**METROPOLITAN GOVERNMENT OF NASHVILLE AND DAVIDSON COUNTY**

**STAFF RECOMMENDATION**  
**3601 Richland Avenue**  
**January 16, 2019**

**Application:** New Construction—Addition; Setback Determination  
**District:** Richland-West End Neighborhood Conservation Zoning Overlay  
**Council District:** 24  
**Map and Parcel Number:** 10409013700  
**Applicant:** Van Pond, Jr.  
**Project Lead:** Melissa Sajid, [melissa.sajid@nashville.gov](mailto:melissa.sajid@nashville.gov)

Figure 2: 1957 Sanborn map

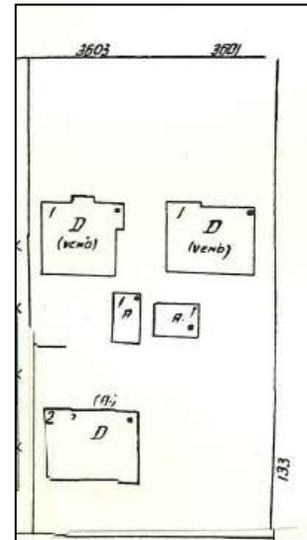
The plan includes an attached garage on the right side of the addition. The design guidelines state that attached garages may be appropriate when they are located at basement-level. While the existing garage, if attached, would not be located at basement-level, staff finds that an attached garage could be appropriate in this case given the depth of the lot and the deep front setback. The historic house is set back approximately seventy feet (70') from the front property line. While the deep front setback is consistent with the context, the lot is shallower than most lots on this block of Richland Avenue. The subject property is approximately one hundred twenty-four feet (124') deep whereas most lots are closer to two hundred feet (200') deep. As early as 1957, the rear of this lot and 3603 Richland Avenue were truncated for the construction of the two-story dwelling at 133 Bowling Avenue (Figure 2).

As a result, the existing house sits only twenty-seven feet (27') from the rear property line. Staff finds that incorporating an attached garage into the addition as proposed would not result in an inappropriate massing for the addition. For these reasons, staff finds that the proposed design, which incorporates the existing garage, could be appropriate in this case.

Figure 3: Existing conditions showing the front setback of the rear property.

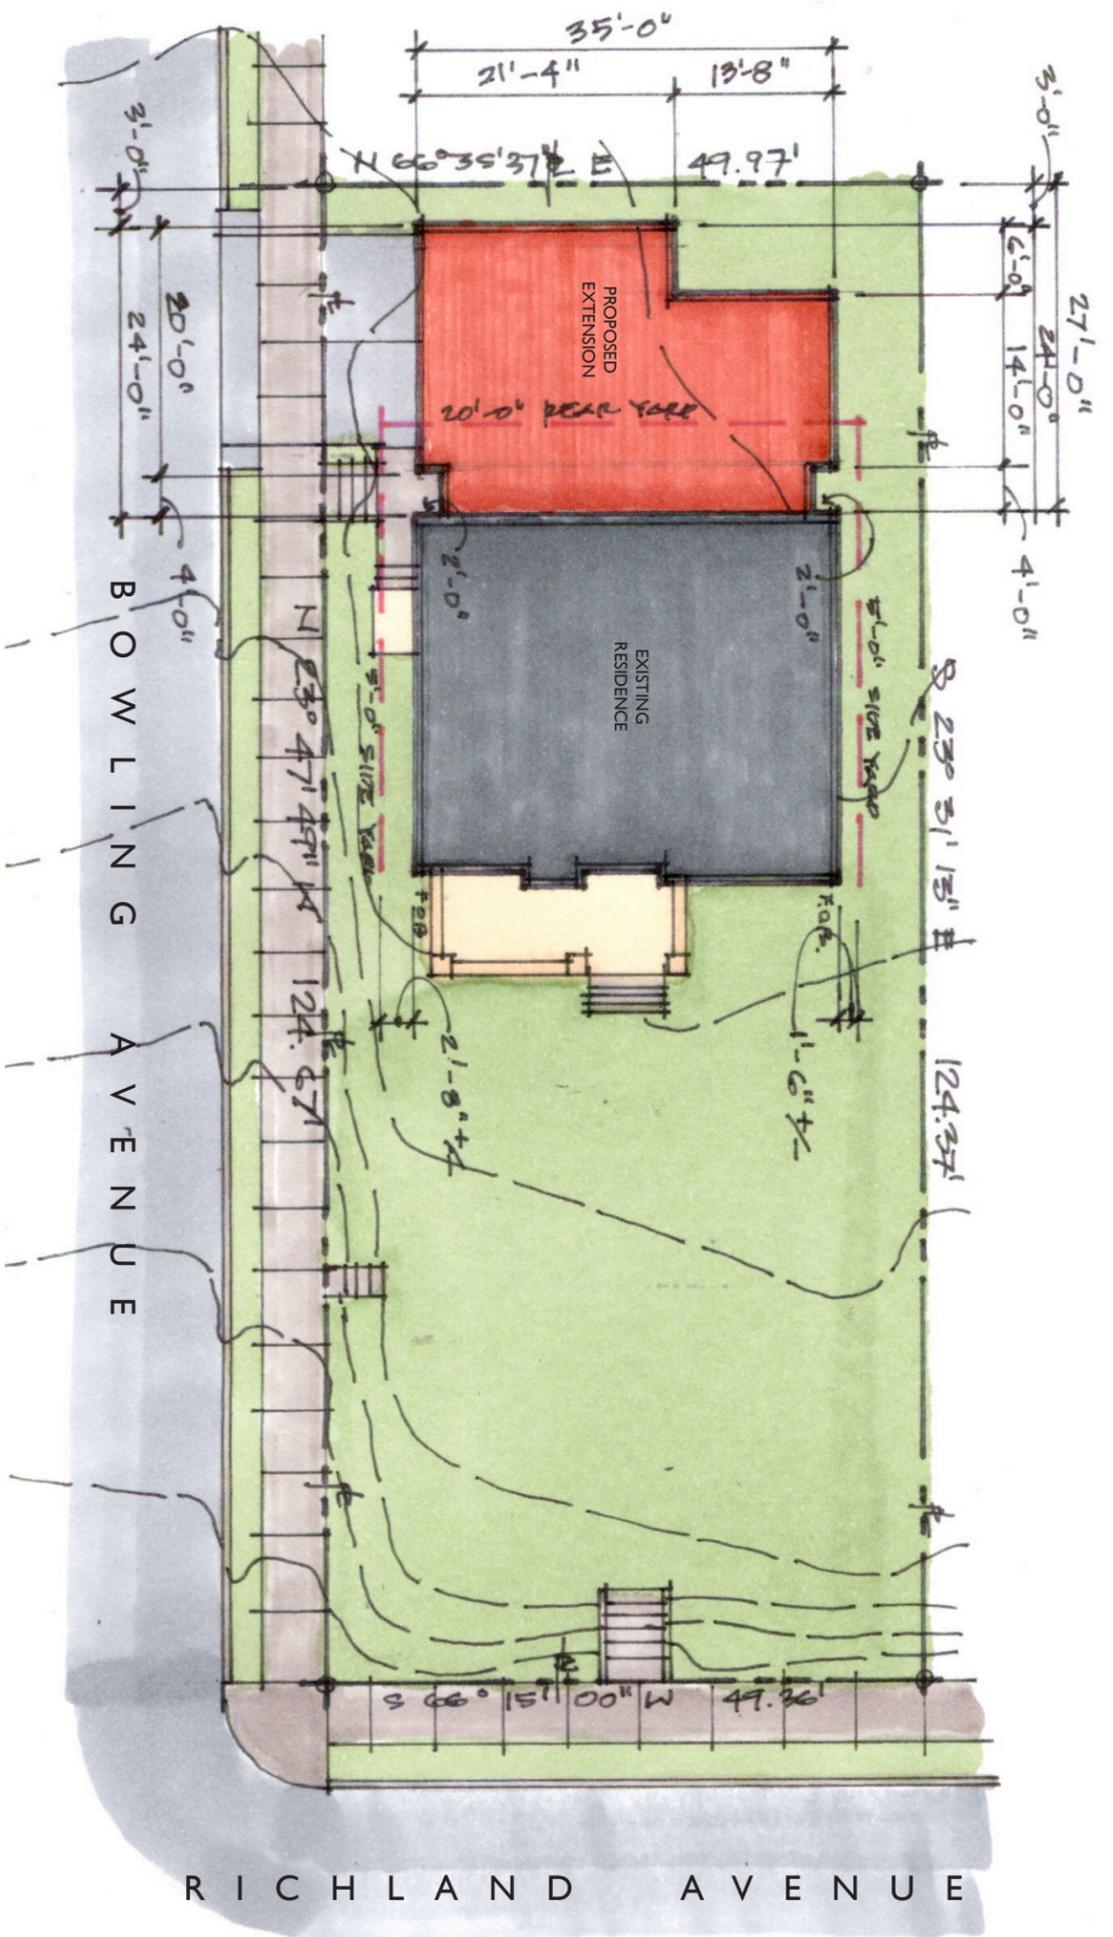
The applicant proposes an addition that would extend the depth of the house by twenty-four feet (24'), which would be located three feet (3') of the rear property line. The Commission has the authority to determine setbacks when doing so is appropriate for the historic context. Given the depth of the lot, staff finds that the reduction of the rear setback may be appropriate in this case but is concerned with the amount of reduction for a lot with no rear alley. In the past, there have been situations in which the Commission has reduced the rear setback to as little as five feet (5').

In this case, the property backs up to the front half of a property that faces Bowling Avenue. Because of the deep setback of 133 Bowling Avenue, staff is concerned that to intrude too far into the required twenty-foot (20') rear setback at 3601 Richland Avenue could have a negative effect on the adjoining property owner. The bulk standards permit a three feet (3') rear setback for accessory structures that have a footprint of less than seven hundred square feet (700 sq. ft.), but in this case, a three feet (3') rear setback is proposed for a primary structure with a footprint of approximately one thousand eight hundred square feet (1800 sq. ft.) and a one and one-half story massing. In addition, a side setback determination on the Bowling Street side is also requested. For these reasons, staff does not recommend that the rear setback is reduced to be less than five feet (5').

With a condition that the rear setback is reduced to be no less than five feet (5'), staff finds that the proposed addition would meet Section II.B.1.c.

PROPOSED SITE PLAN

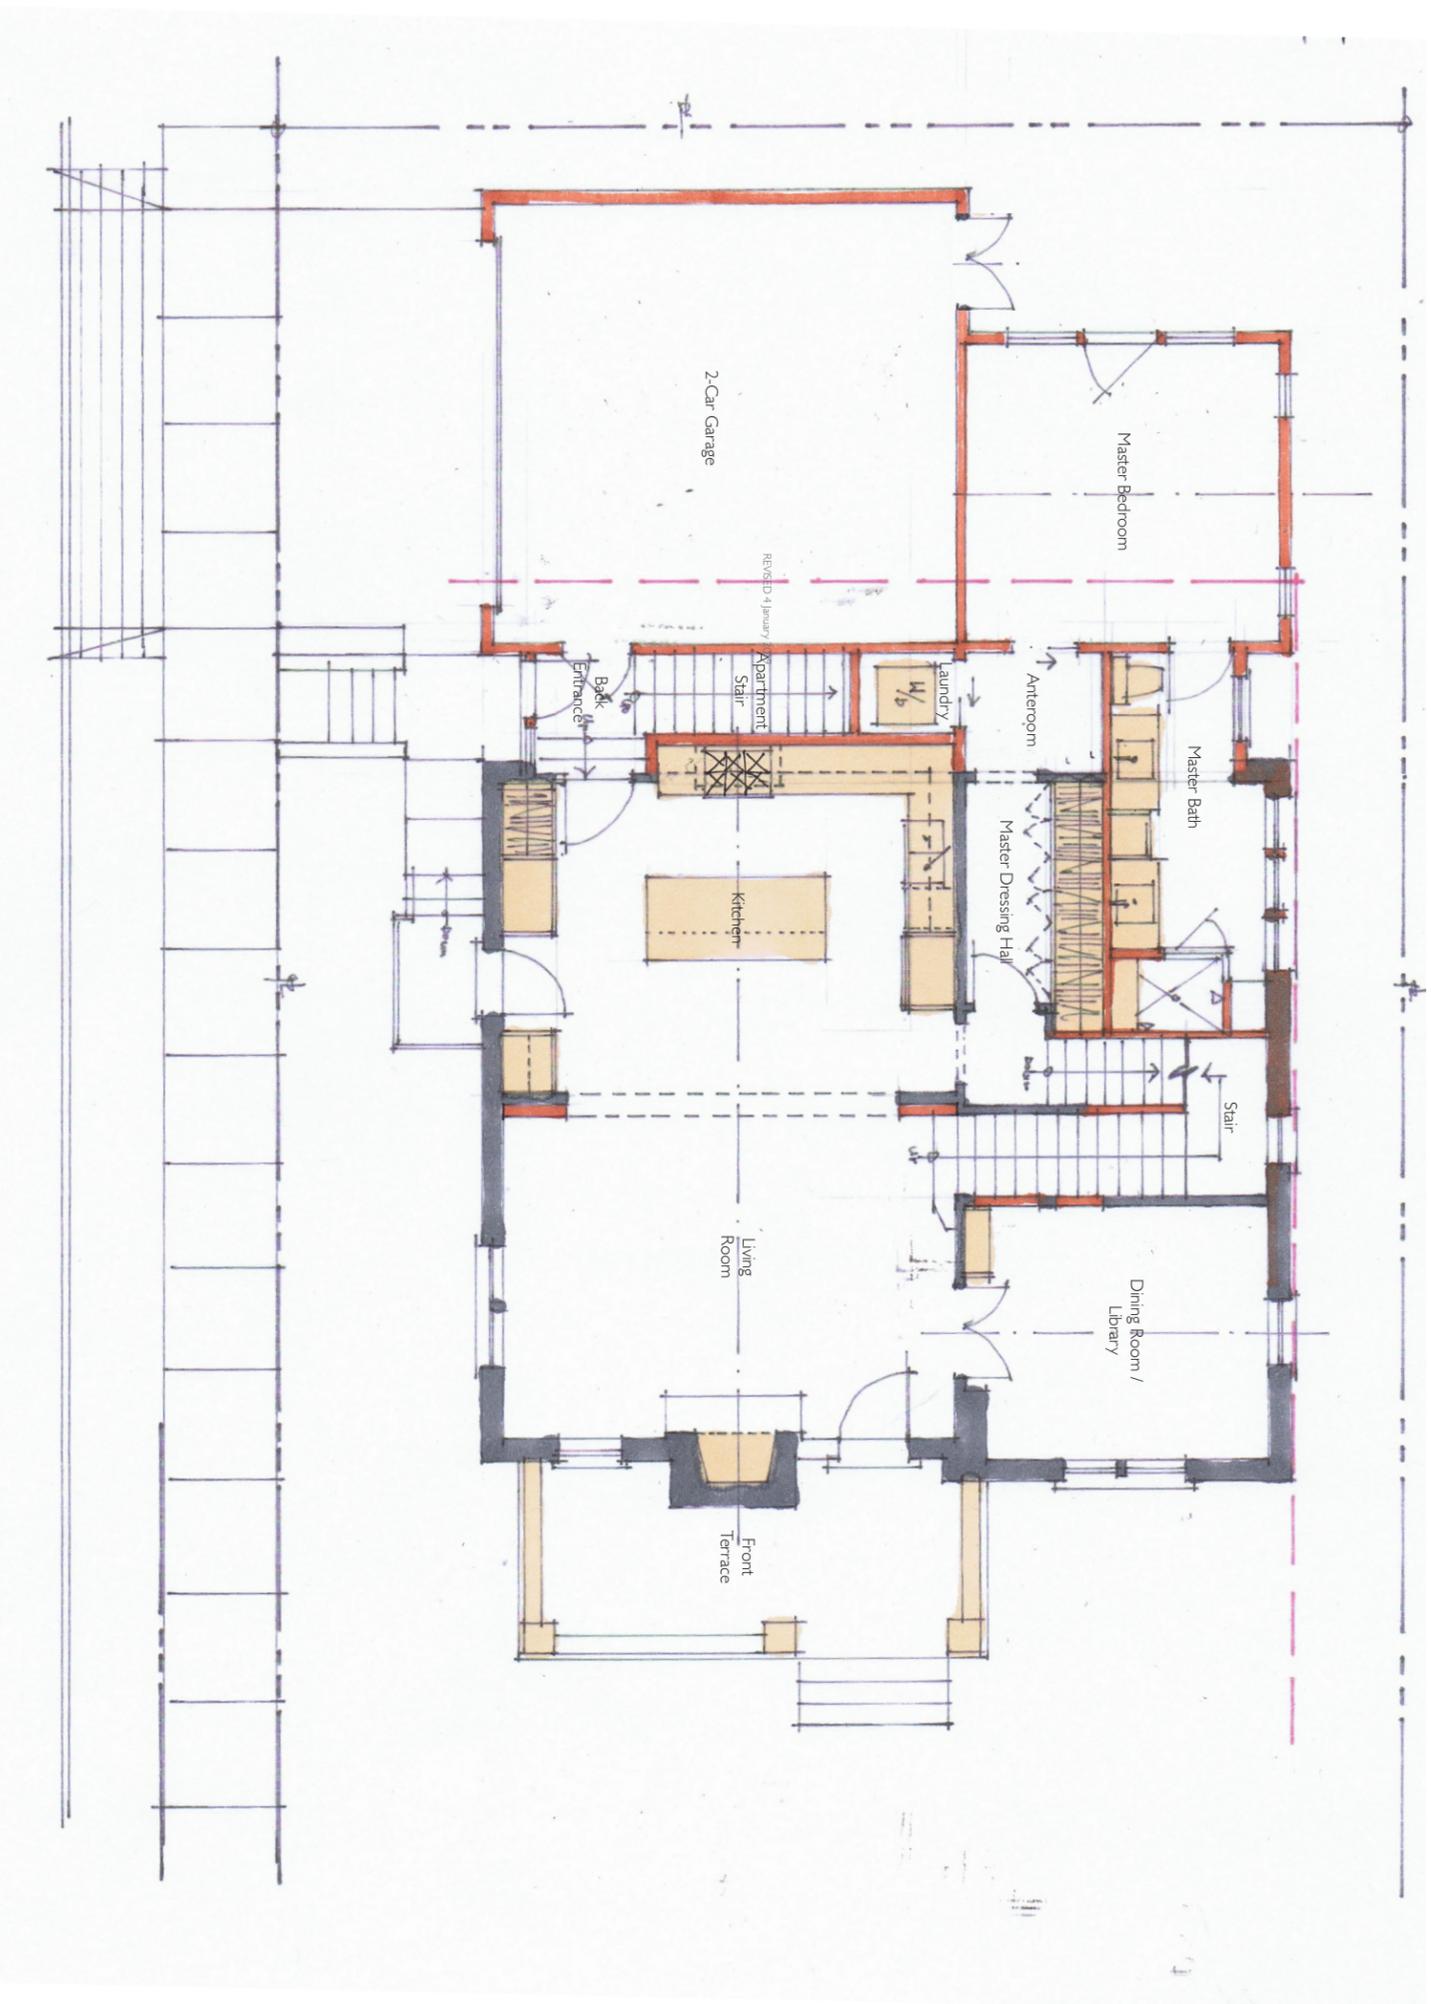
Setback & Rhythm of Spacing: The site is a corner lot, and the house is located only twenty-seven feet (27') from the rear property line. With a standard rear setback requirement of twenty feet (20'), the buildable area behind the house would be limited to

approximately seven feet (7') deep. In addition, the house is located eight feet (8') from the side property line along Bowling Avenue while the bulk standards typically requires ten feet (10') for new construction but increases to twenty feet (20') in cases where garage doors face the side street.

The applicant also requests to reduce the left side from twenty feet (20') to eight feet (8'). Staff finds that the requested side setback determination along the Bowling Avenue property line to be appropriate as the addition is no wider and will be no closer to the side property line than the historic house.

1. The rear setback shall be increased to a minimum of five feet (5');
2. Staff approve the final details, dimensions and materials of the foundation, roof color, windows, doors, and garage doors prior to purchase and installation; and
3. If relocated, the HVAC shall be located behind the house or on either side, beyond the mid-point of the house.
